#### Report to the Future Melbourne (Planning) Committee

Agenda item 6.3

18 September 2018

Ministerial Planning Referral: TPM-2015-28 293-297 City Road, Southbank

#### Podium City Road

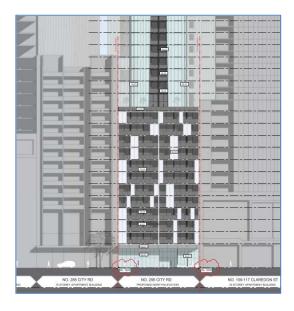
The podium height to City Road is approximately 39 metres and to the balustrade is approximately 40 metres. Council's Urban Design department has commented:

The podium height to City Road is supported, which appears to respond sufficiently to the varied heights of adjacent podium elements.

The 5 metre setback of the tower to City Road is appropriate to the urban context noting this setback is greater than the two adjoining buildings and is supported in its current form.

Podium Hancock Street

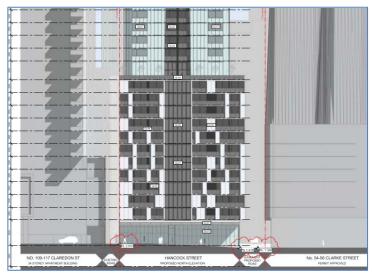
The podium height to Hancock Street is approximately 39 metres and to the balustrade is approximately 40 metres. The tower is setback 2 metres from Hancock Street above the podium. Council's Urban Design department has commented:

The podium height to Hancock Street, in combination with the setback significantly reduces the quality of space within Hancock Street. A height which responds to the adjacent 'shoulder' of 109 City Road is strongly preferred, with a minimum setback of 5m to reduce the dominance of the tower within this narrow streetscape.

Given the above, it is considered that the proposed podium height and tower setback to Hancock Street meet the relevant built form outcomes of DDO60 and can be supported as the proposed built form is consistent with the existing and emerging adjacent approved built form and will provide a human scale to the streetscape with the use of an activated façade and a canopy.

Tower setback above podium TP-2018-570 54-56 Clarke Street

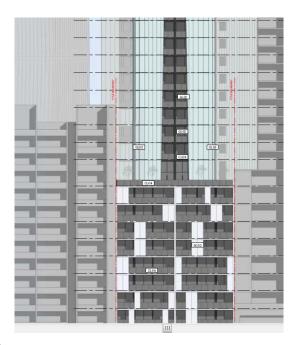
The south eastern tower has a setback of 8.3 metres to the eastern boundary with the living areas of those apartments generally orientated to the south. This arrangement provides good daylight, privacy and outlook for the proposed apartments and provides adequate development opportunity for the site to the east. A current planning application, TP-2018-570 for the property to the east, 54-56 Clarke Street, proposes the tower to be setback 3.4 metres above a 5 level podium, with an apartment orientated to the west. This provides a potential separation between towers of 11.7 metres which meets the discretionary minimum requirement of 10 metres.

The proposed 8.3 metre setback will ensure that some separation between towers is maintained along Hancock Street to avoid the buildings appearing as one continuous wall.

Given the above, the proposed south eastern tower setback is in accordance with DDO60 and can be supported in this context.

City Road tower separation

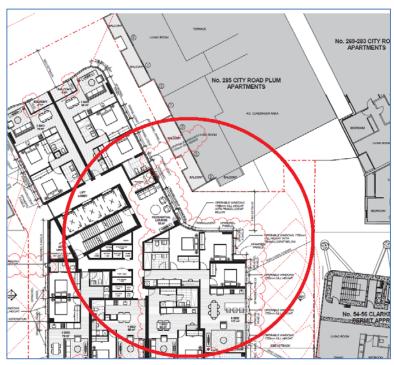
Mid-block in the eastern tower, at level 16 and above, a new two bedroom central apartment is included in the typical floor plate on the eastern side of the building, setback 4.78 metres from the boundary with views over the roof of the adjoining apartment development at 285 City Road. Levels 13 to 15 have three bedroom dwellings within the same footprint with bedrooms located in the central area which are provided with appropriate screening to avoid overlooking of the adjoining living areas of the existing apartments to the north. Having regard to the poor and constrained outlook of the proposed two bedroom central apartments at Levels 16 and above, it is considered appropriate to request a condition requiring these dwellings to be consistent with the three bedroom dwellings within Levels 13-15 to increase the amenity afforded to the dwellings within the upper tower and maintain a dual aspect arrangement for these dwellings.

- a) The two bedroom dwellings located on the central eastern boundary from Level 16 and above to be integrated with the adjoining two bedroom apartment to the south to provide for a three bedroom dwelling consistent with the three bedroom dwellings within Levels 13-15 in the same location.

# West Tower Setbacks and Tower Separation

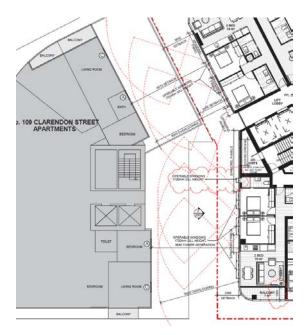
The north western tower of the proposed building is setback 3.38 metres from the western boundary and the adjoining tower to the west is setback 6.19 metres from the boundary resulting in a tower separation of 9.57 metres.

The south western tower of the proposed building is setback 2.38 metres from the western boundary and the adjoining tower to the west is setback 7.305 metres from the boundary resulting in a total separation of 9.685 metres.

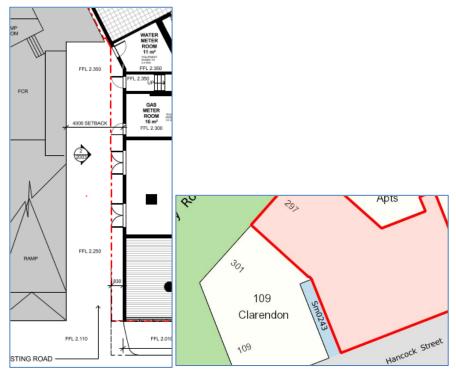
- Council's waste and traffic departments have advised that an 8.8 metre long Council Medium Rigid Vehicle (MRV) must be used to service the development. The departments have also advised that an MRV can reverse into the site, collect the rubbish and drive out in a forward direction. However the WMP submitted with the application does not reflect this arrangement and must be amended accordingly.
- A revised hard waste area and a commercial waste area are required and must be shown in a revised WMP.

Councils Waste Services Team has advised that these matters can be addressed via a condition of permit in this instance.

- Revised swept path diagrams which show that the Council MRV can reverse into the development and then drive out in a forward direction, the diagrams must also factor in height clearances. These swept path diagrams must be attached to the WMP.
